MONSON-SULTANA JOINT UNION ELEMENTARY SCHOOL DISTRICT

8.13 CHANGE ORDER - GYMNASIUM PROJECT

Change Order Request

School Name:	<u>Monson Sultana Joint Union School District</u>	Ref. No.:	_____
Project Name:	<u>Monson Sultana Elementary Relocatable</u>	Date:	<u>6/14/2024</u>
To:	<u>Roberto Vaca</u>	Project Number:	<u>1-4-23015</u>
From:	<u>KYA Services, LLC</u>	Contract Number:	<u>04-119252</u>

PARTIAL SITE PLAN

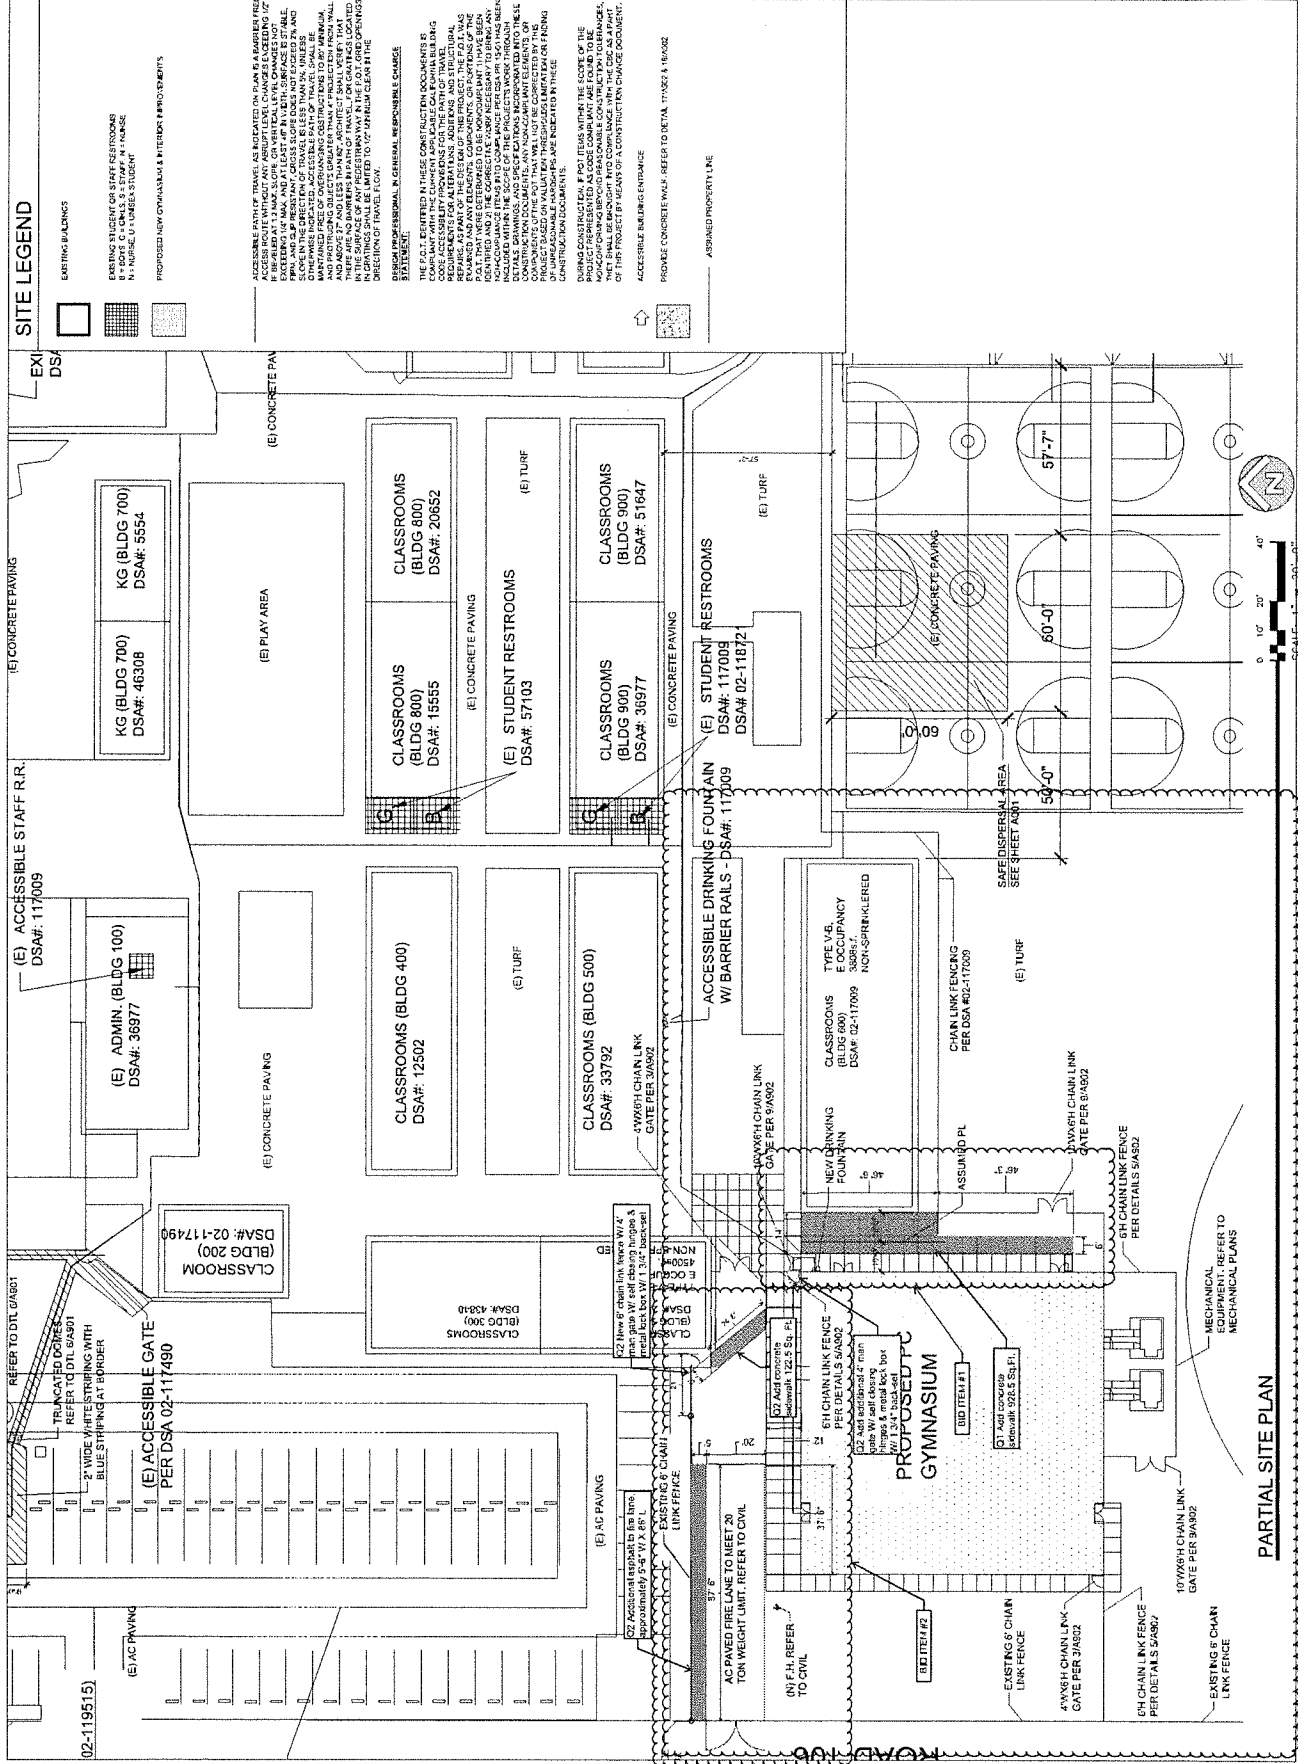
Description of Work: Per the client Beto Vaca, he is requesting additional concrete per the attached plan. The cost reflects compaction, labor and material.

A. Subcontractor Cost of the Work		
<u>Additional concrete between Mods & Gym</u>	<u>\$ 12,100.00</u>	
<u>For Additional sidewalk from Cafeteria & Gym</u>	<u>\$ 1,800.00</u>	
_____	<u>\$ -</u>	
_____	<u>\$ -</u>	
_____	<u>\$ -</u>	
_____	<u>\$ -</u>	
_____	<u>\$ -</u>	
		Subtotal A: \$ 13,900.00
